Sundry Print Report

Well Name: DOS EQUIS 12-13 FEDERAL COM

Type of Submission: Notice of Intent

Type of Action: APD Change

WELL LOCATION AND ACREAGE DEDICATION PLAT

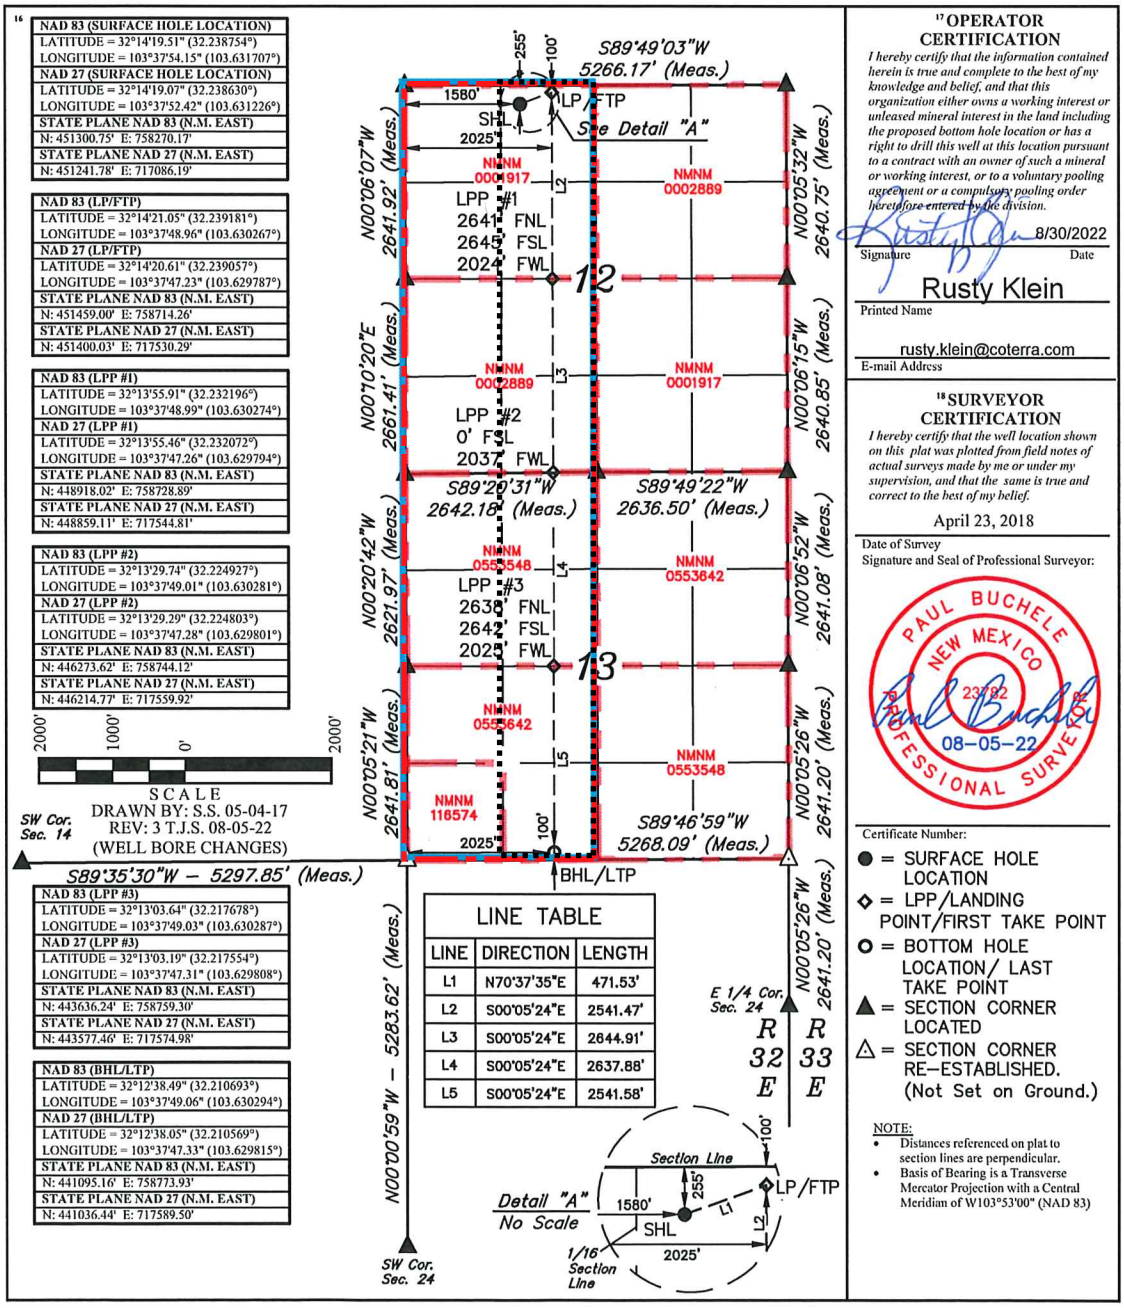
Procedure Description: Cimarex Energy Company respectfully requests to change the FTP, BHL, formation and pool, proposed total depth and change the drilling plan as follows: FTP change: From: 255' FNL & 1580 FWL, Unit C, Sec 12, 24S, 32E To: 100' FNL & 2025' FWL, Unit C, Sec 12, 24S, 32E BHL change: FROM:100' FSL & 1386' FWL (Unit N, SESW) of Section13-T24S-R32E To: 100' FSL & 2025' FWL (Unit N,SWSE) of Section13-T24S-R32E The Pool will also be changed as follows: FROM:WC-025;G-08;S243213C;Wolfcamp (Pool Code 98309) TO: Triple X; Bone Spring, West (96674) Proposed Total Depth will be changed as follows: FROM:22379'MD/12340'TVD TO:20048'MD/10167'TVD The drilling plan will be updated to include a request for approval to perform off-line cementing and request approval to skid the rig to the next well on the pad to begin operations instead of waiting 8 hours for surface casing cement to harden before skidding rig.

FROM:WC-025;G-08;S243213C;Wolfcamp (Pool Code 98309)

TO: Triple X; Bone Spring, West (96674)

Proposed Total Depth will be changed as follows:

FROM:22379'MD/12340'TVD

TO:20048'MD/10167TVD
